TECHNICAL EVALUATION REPORT

HYDROLOGICAL CONSIDERATIONS

COMMONWEALTH EDISON COMPANY

DRESDEN STATION UNIT 2

Figure 17. PMF Hydrographs for the Des Plaines, Kankakee, and Illinois Rivers

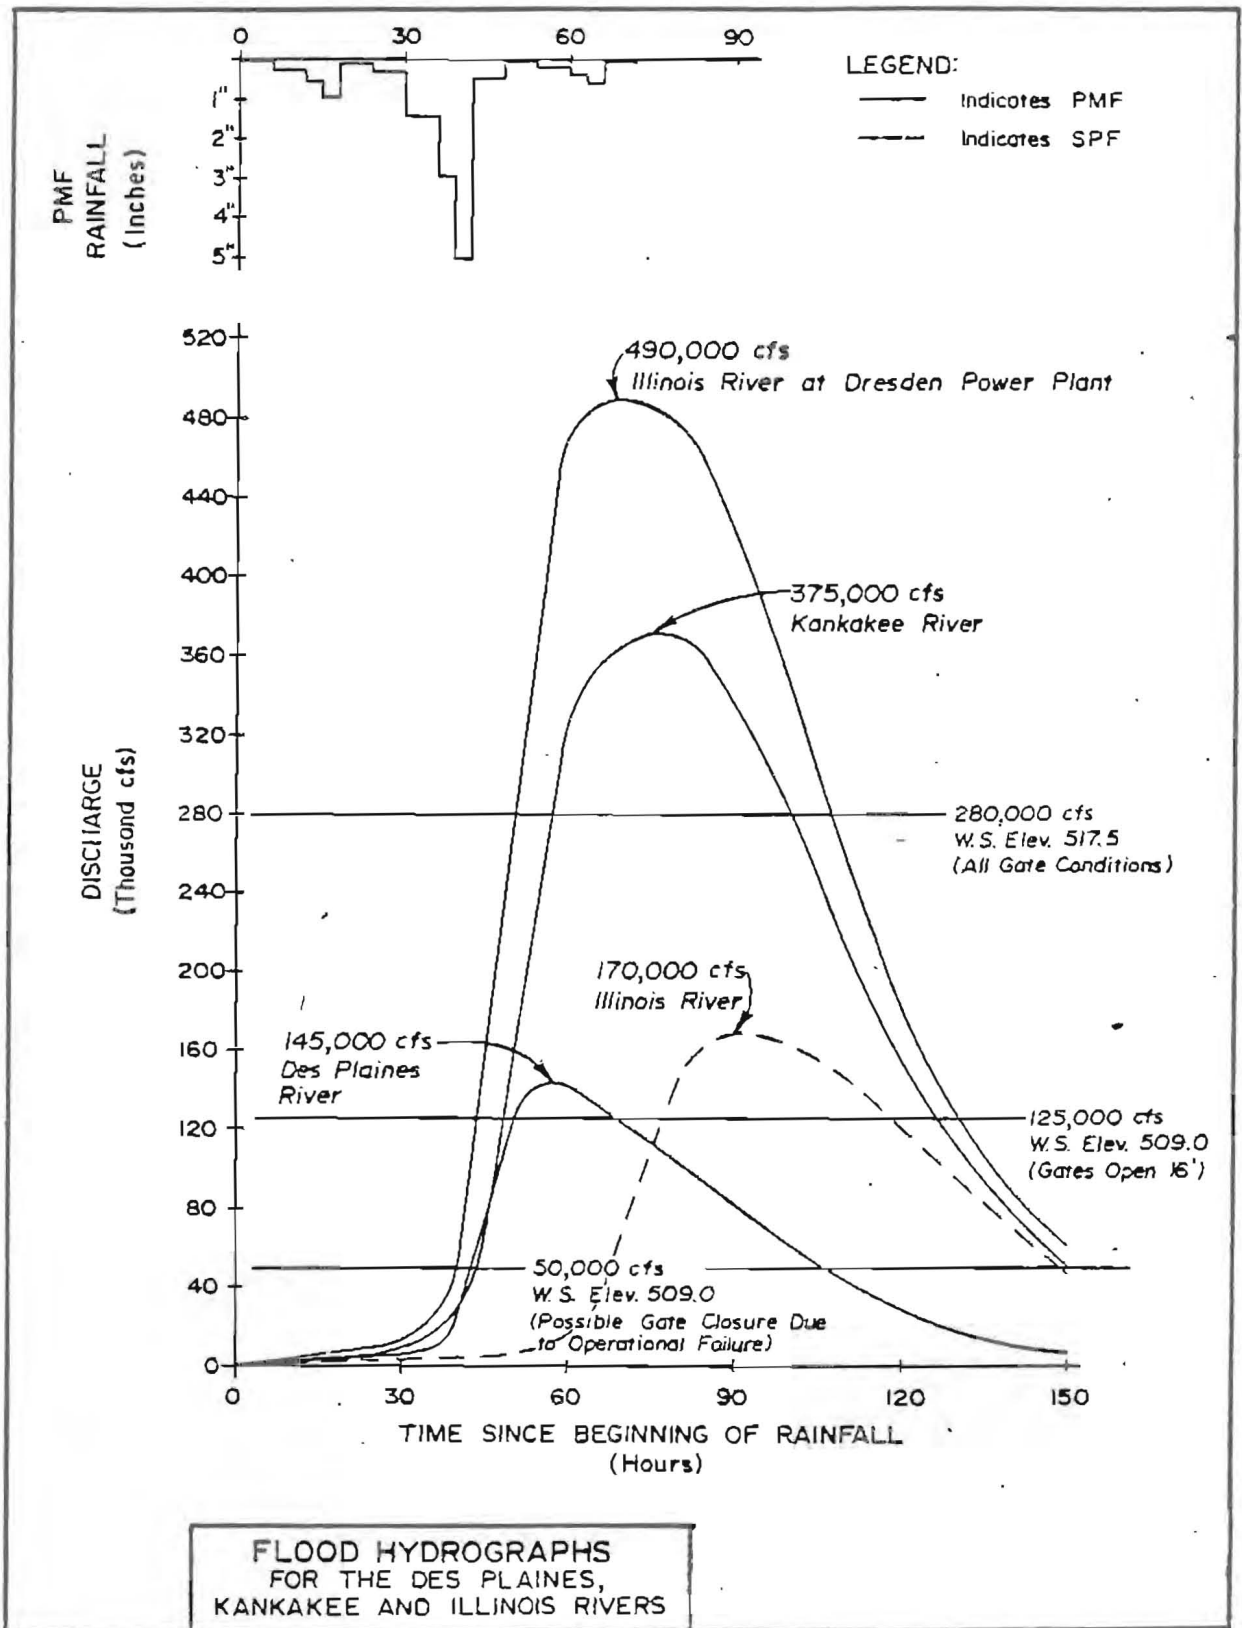
Figure 17 contains the PMF hydrographs for the Des Plaines, Kankakee, and Illinois Rivers. The peak discharge for the Des Plaines River was 145,000 cfs, and the peak flow for the Kankakee River was 375,000 cfs. The combined flood peak for the Illinois River hydrograph was computed to be 490,000 cfs. Base flow was not incorporated in the computer model since river flow is less than 10,000 cfs for 80% of the year (31).

The rising limb of the PMF hydrograph for the Illinois River at Dresden is steep and has a lag time of approximately 75 hours. This is the time from the beginning of rainfall to the hydrograph peak. There is also a delay of about 24 hours before the hydrograph rises. It must be recognized that a theoretical hydrograph such as that shown in Figure 17 should be used with caution in evaluations of emergency procedure timing since actual vs. theoretical hydrographs can differ by several hours in either direction.

The PMF for the Illinois River at Dresden was based on a computer model calibrated from the 1957 data. Urbanization since 1957, which is localized in the greater Chicago area, might result in a peak discharge different than calculated for the Des Plaines River. The Kankakee River Basin seems to have changed very little since 1957. Therefore, the simulated Kankakee hydrograph is considered valid. The PMF for the Illinois River at Dresden, for present-day conditions, may peak sooner and higher than predicted because of postulated change in the peak discharge for the Des Plaines River. However, it is expected that any such change in the reported PMF hydrograph would be within the range of uncertainty of the model itself. Extensive recalibration of the runoff model, based on data for current hydrologic conditions, would be

Figure 18. Fetches for Wave Generation

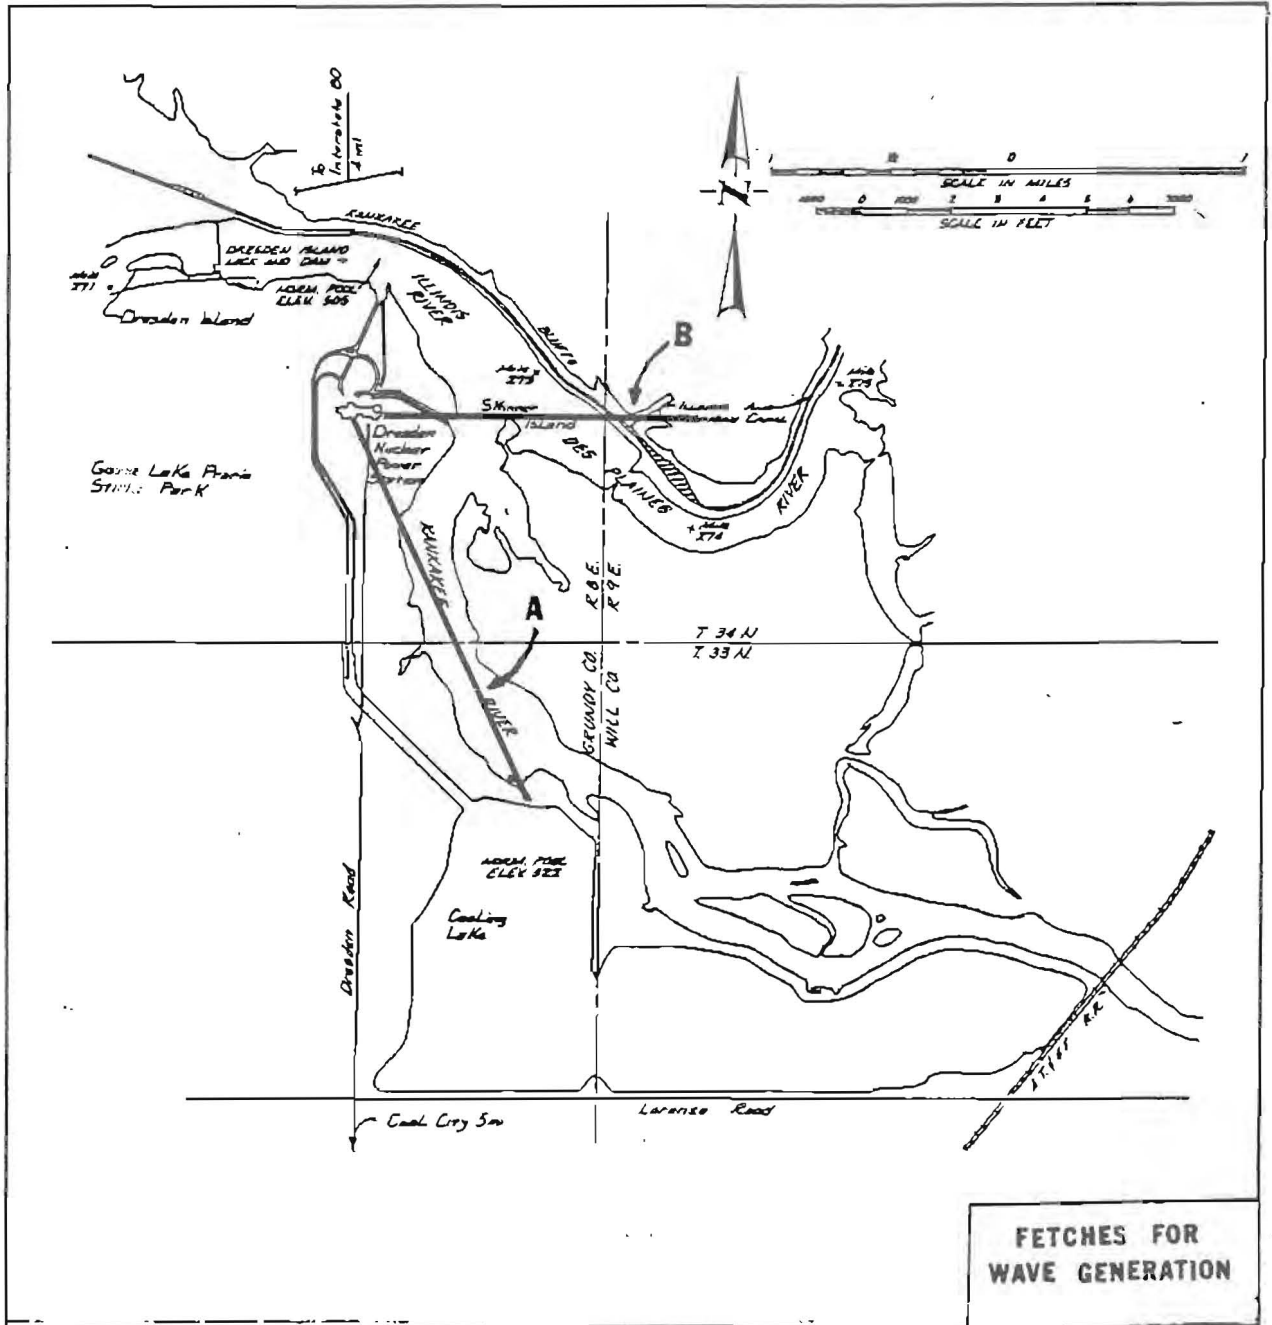
The highest wind speed with a 2-year frequency of occurrence is 50 miles per hour. Two fetches were investigated: one to the southeast of the plant in the Kankakee River (designated A in Figure 18) and the other directly east of the plant across the Kankakee and into the Des Plaines River (labeled B in Figure 18). The critical condition is produced by waves generated on the Kankakee River, which would be 2.6 ft high when they reached the Unit 2 safety-related structures. Wave runup reaches 3 feet above stillwater level. This calculation is a conservative estimate based on procedures outlined in the Shore Protection Manual [32]. A PMF stillwater level of 524.5 ft plus a 3 ft wave runup results in a PMF level of 528 ft.

Figure 20. Site Drainage Map

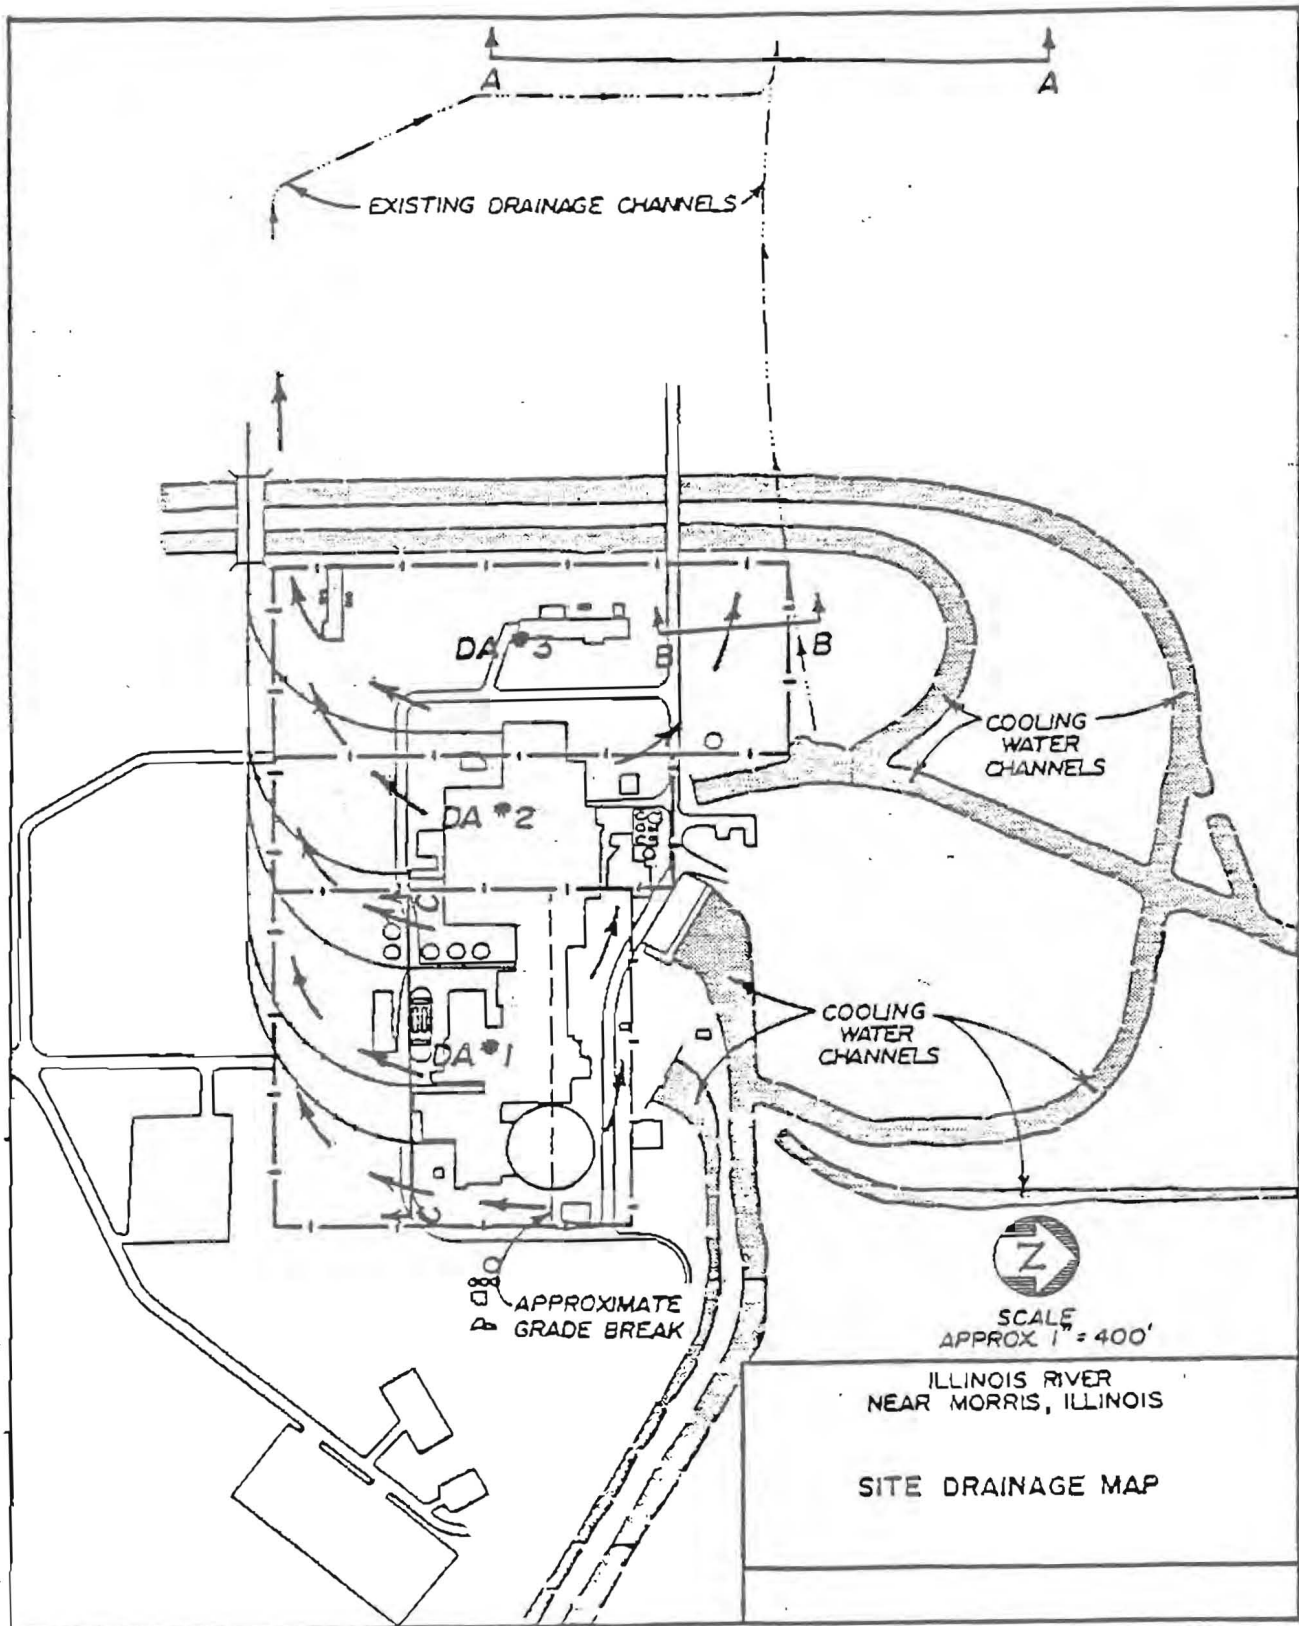
Three representative watersheds within the plant boundaries were delineated for the runoff analysis as seen in Figure 20. These drainages were small in size and were located adjacent to and including the reactor buildings and ancillary facilities. The surface area ranged between 6.7 and 12.4 acres, and the time of concentration for the three basins ranged from 11 to 14 minutes. Idealized flow lines are also shown in Figure 20.

The largest of the three watersheds drains in a southwesterly direction toward the cooling lake canals. Cross sections of this watershed were digitized and used in the flood routing procedure for the local runoff. The 24-hour maximum probable point precipitation is 31.2 in (30) and the maximum 13-minute intensity is 58.3 in per hour (39). The 13-minute time of concentration was found to be the average for the three onsite drainage areas delineated and was used to calculate the precipitation rate of 58.3 in per hour.

Two site drainage analyses were performed to determine the depth of flooding adjacent to plant buildings resulting from point precipitation equivalent to the PMP. The first analysis investigated the influence of the downstream cross section on the conveyance in the vicinity of the buildings. The depth of water at the base of the building was estimated from the second set of calculations.

The first site drainage analysis assumed that the PMF from the three designated drainage areas occurred simultaneously and, therefore, could be combined and routed through a single drainage channel located on the south and west sides of the plant. This represents a conservative estimate of both maximum discharge and runoff volume. This channel was analyzed to determine its capacity to convey flood waters, which showed that for a water surface at plant grade the channel can carry twice the flood generated by the PMP.

Drainage area No. 1, in actuality, drains both to the north and to the south rather than just to the south as modeled in the first set of calculations. The drainage divide is located north of the east-west midline of the buildings as shown in Figure 20. Approximately 3.1 acres drain to the north and 9.3 acres drain to the south.

A cross section was placed on an east-west line located south of and adjacent to the plant buildings in area No. 1. The location of the section, seen as Section C-C on Figure 20, was selected for several reasons including its proximity to the buildings, the large surface area adjacent the section occupied by the buildings, and the lack of defined drainage swales or channels. The cross section can be described as a broad, flat, flood plain and represents the worst-case situation.

The hydraulic analyses show that the water surface elevations created by the onsite PMF will not exceed the finished floor elevation of the plant. The analysis revealed that the slope of the land surface was sufficient to carry away runoff generated from high intensity rainfall equivalent to the PMP without the flood level exceeding elevation 517.5 ft msl.

Figure 21. Critical-Time Hydrograph for the Illinois River

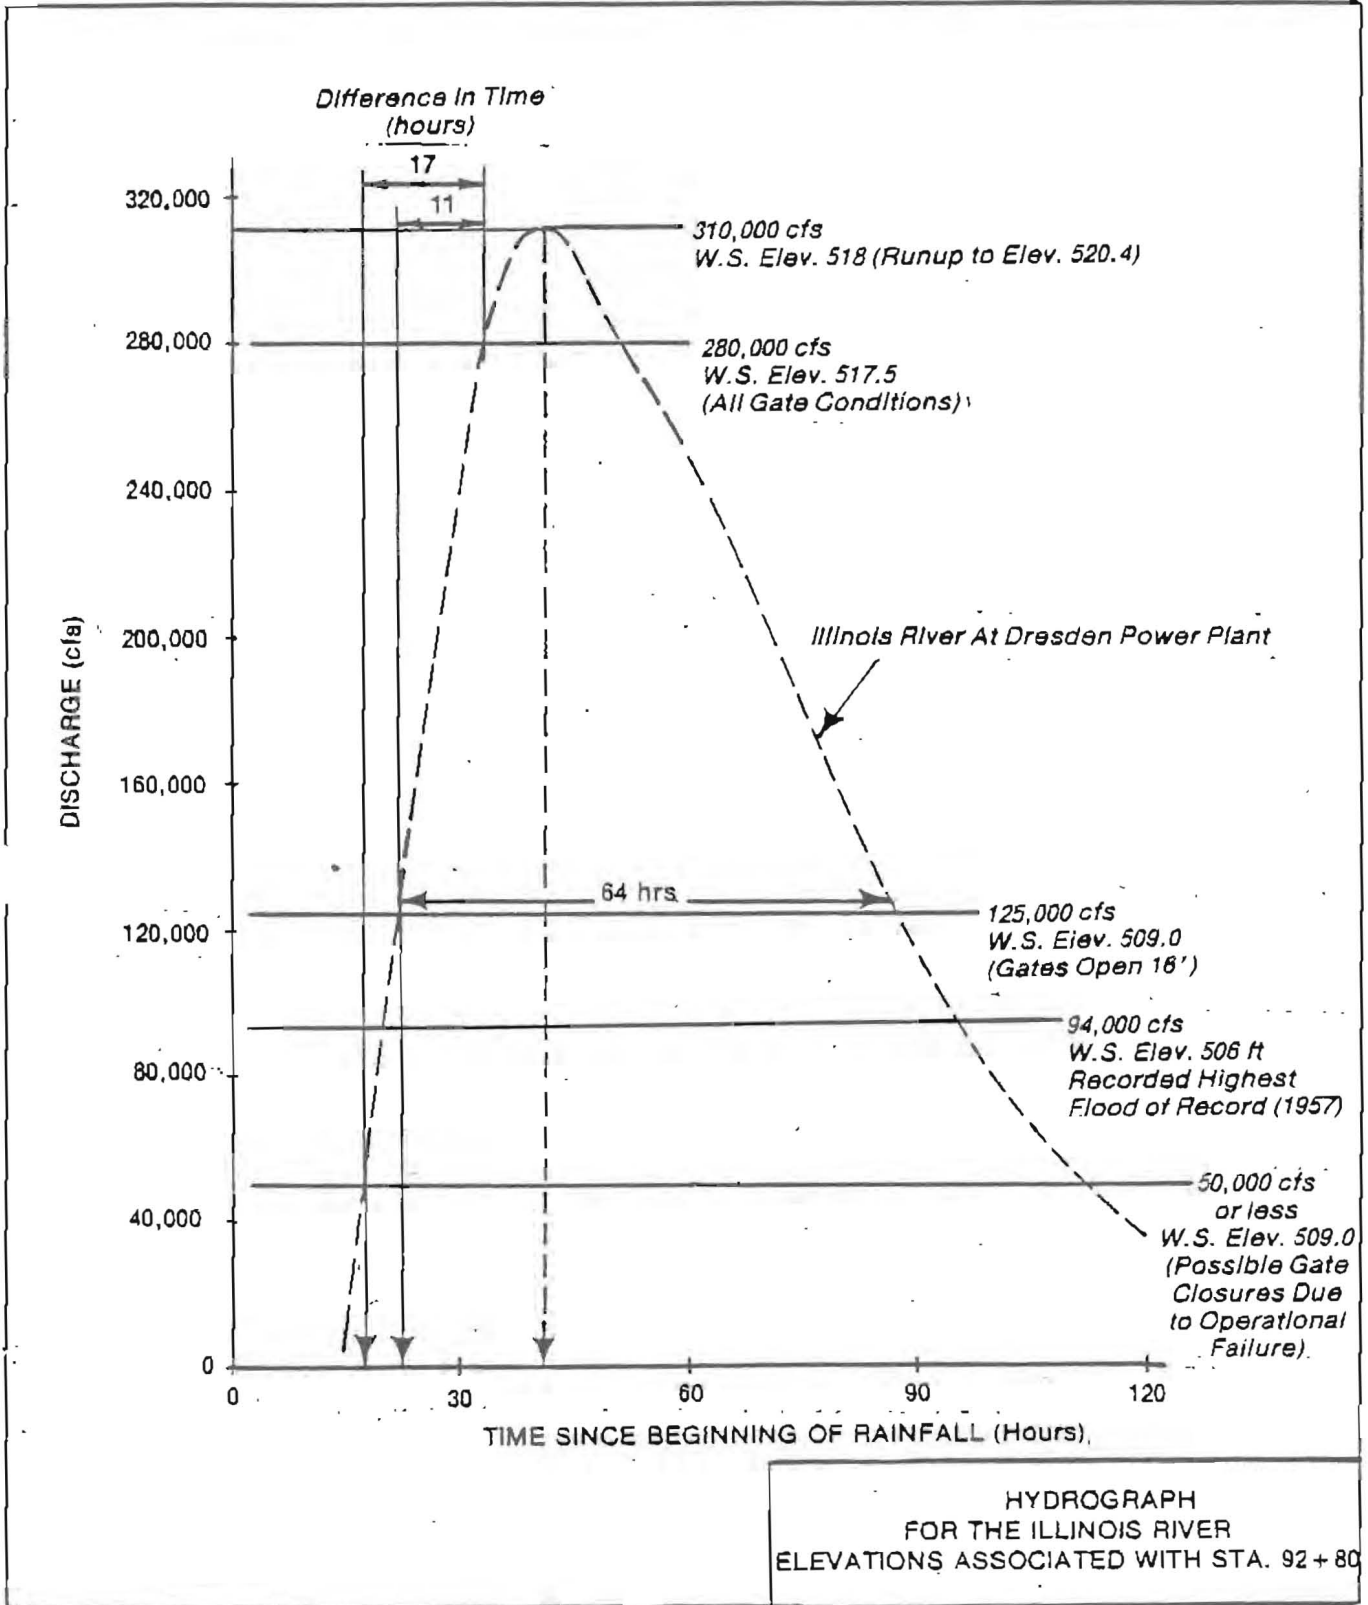
The critical-time flood hydrograph shown in Figure 21 graphically depicts the relationship of flood elevation to time (hours) since the beginning of the limiting rainfall event. The following information can be obtained from the critical-time hydrograph.

- o For low elevations (i.e., small discharges), the configuration of tainter gates at Dresden Dam has a great effect on stream elevations.
- o Assuming gates open to 16 ft, 22 hours will be available from the onset of rain until the Illinois River reaches the elevation of the service water pumps (509 ft msl).
- o Assuming gates open to 16 ft, 33 hours will be available from the onset of rain until the Illinois River reaches elevation 517.5 ft msl (plant grade).
- o Assuming gates open to 16 ft, flood waters will be above elevation 509 ft msl for approximately 64 hours (2.75 days), and for a longer time during the PMF.
- o Assuming gates open to 16 ft, flood waters will rise from elevation 509 to 517 ft in approximately 7 hours during the PMF.

A flood emergency procedure should anticipate a flood which threatens the site sufficiently in advance of the occurrence of the flood to allow adequate time to place the plant in a safe shutdown condition (cold shutdown). Ideally, this shutdown procedure should be accomplished using normal shutdown procedures within approximately 28 hours (4 hours condenser cooling plus 24 hours reactor shutdown cooling system). However, presuming a rapid rise of water which hampers the operation of normal cooldown mechanisms, the emergency procedure should also identify the alternate cooldown plan and elaborate upon the mechanisms and equipment used in the alternate cooldown procedure.
